PROJECT MEMORANDUM

Subject: December 8, 2015, Scoping Meeting
KEO Homestead Subdivision
SWC Section 24, Township 6N, Range 1E
Parcel No: 20-015-0010
Huntsville, Utah

FIGURE 2
PROPOSED
WORK PLAN

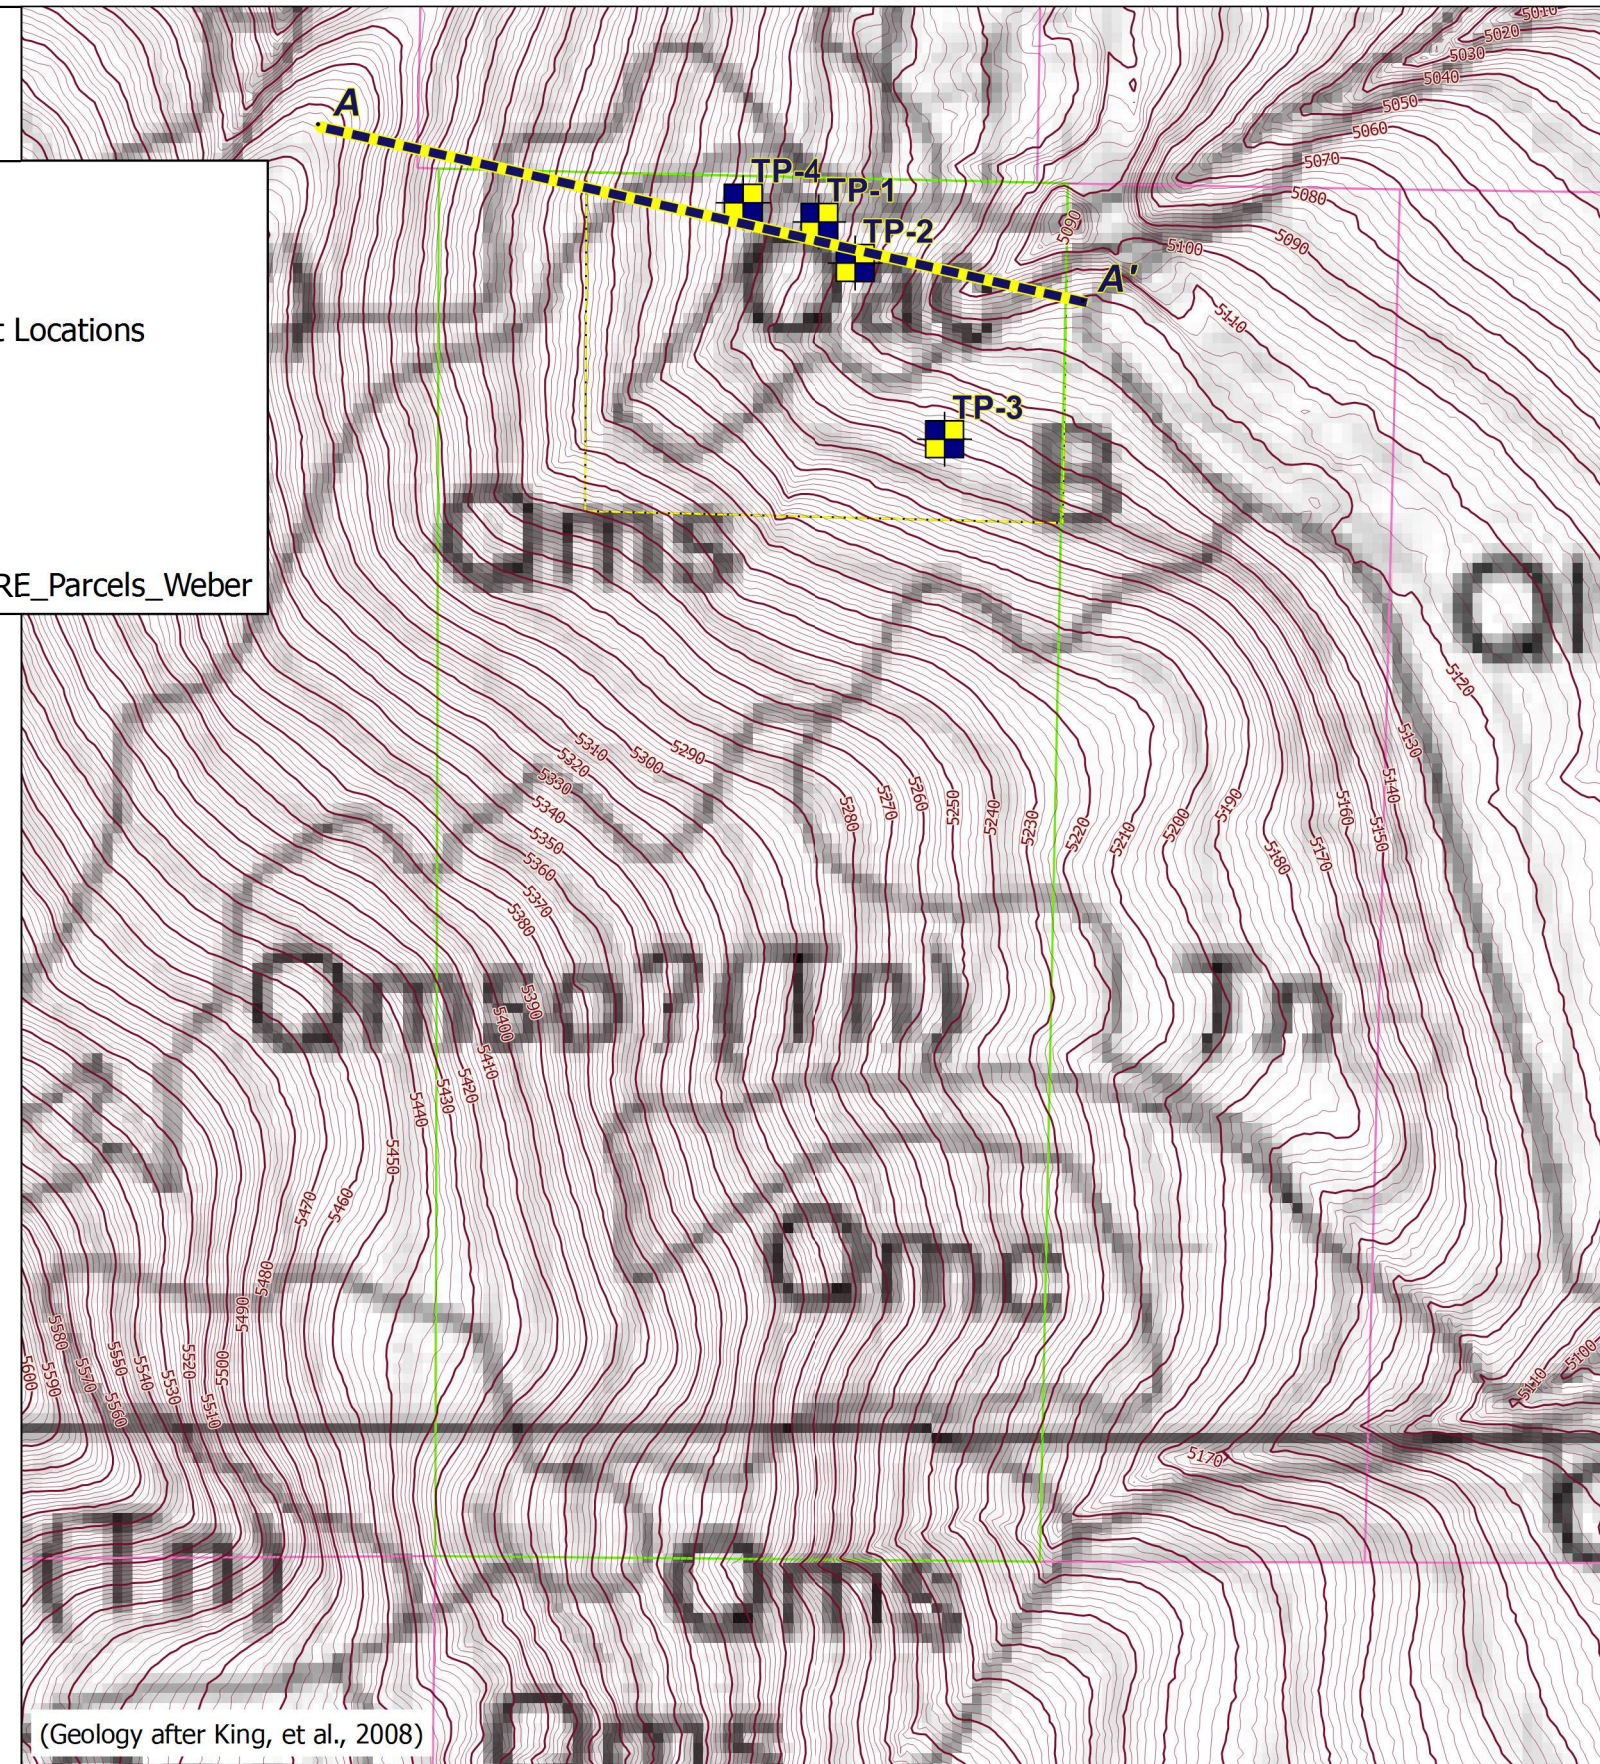
- a. GSH previously completed a geotechnical study for the site and will provide the study on Miradi.
 - b. Test pits were located to provide subsurface data for proposed slope stability cross section A-A', shown on the attached GSH Figure 2, Proposed Work Plan.

Mr. Simon noted that designing a program of subsurface exploration to yield data for a cross section may be premature considering the site is mapped as being underlain by landslide deposits; determining whether or not there are landslide deposits within the proposed development area should be the first task.

4. Mr. Schlenker proposed possible trench locations near TP-1 and TP-3 on the attached GSH Figure 2, Proposed Work Plan. Mr. Simon thought those were appropriate locations, but suggested again that GSH may want to review LiDAR imagery prior to submitting a modified subsurface exploration program.

- a. The slope cross section depicted on the proposed work plan is not perpendicular to slope. Slope stability cross sections should be perpendicular to slope.
